Delegated officer report for planning application

Application no. 141805/LO/2024

Proposal: Listed Building Consent for the installation of floor mounted air sourced heat pumps and enclosure, replacement flat roof coverings and rooflights, replacement external windows and doors and installation of cavity injected wall insulation.

Address: Blackley Cemetery Office And Yard, Victoria Avenue, Blackley, Manchester, M9 8JP

Figure.3: Proposed location of ASHP and enclosure

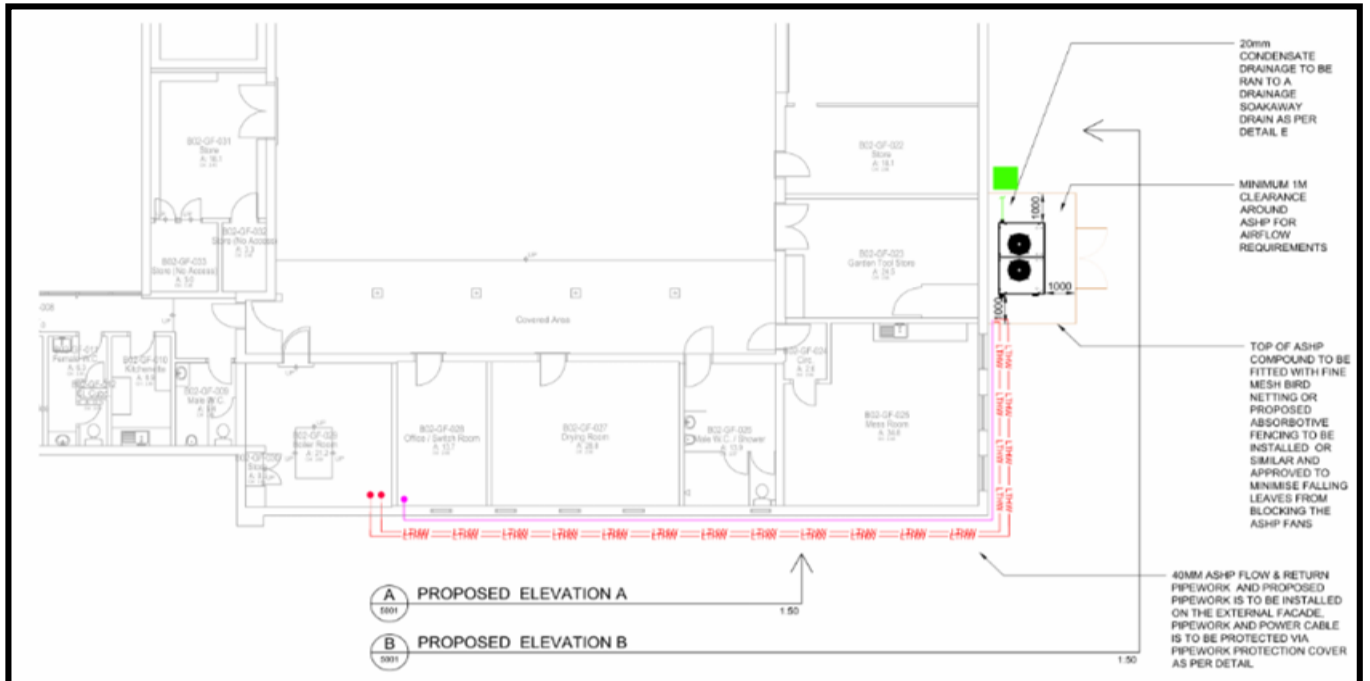
In this application, the proposal is to site a cascade system of 1no. Ideal Ecomod R290HT 50 KW in a fenced enclosure at the rear of the service yard (northeastern elevation) beyond the open courtyard. This is considered a discreet location which was discussed on the site visit in September 2024. There is no reason for the public to access this part of the site which has topography that slopes down towards the building comprising of a grassed and treed bank.

The ASHP would sit against the rear wall as shown on drawing: 3390-CWC-XX-ZZ-DR-M-5001 Rev T3 enclosed within a 3m high Jakoustic Absorptive acoustic fence with meshed top to address leaf fall. Timber gates for access and maintenance would be sited on the northeastern elevation.

The plant would be connected to the boiler room on the southeastern elevation by pipework and cabling running at a low level along the external walls, entering the boiler room via 3no. 200mmØ penetrations low down on the wall. These would be enclosed within a 700mm deep x 20-metre-long covered cable tray which would screen their external appearance. The cover, also shown on drawing no: 3390-CWC-XX-ZZ-DR-M-5001 Rev T3, is dark coloured which will help to minimise its appearance against the brick elevations.

In heritage terms, this work is supported, the Council is confident that NPPF para.212 is satisfied; the location of the ASHPs and associated pipework is an area that makes little contribution to the special interest of the building, the level of harm is at the lower end of less than substantial and is outweighed by significant public benefits which are fully justified.
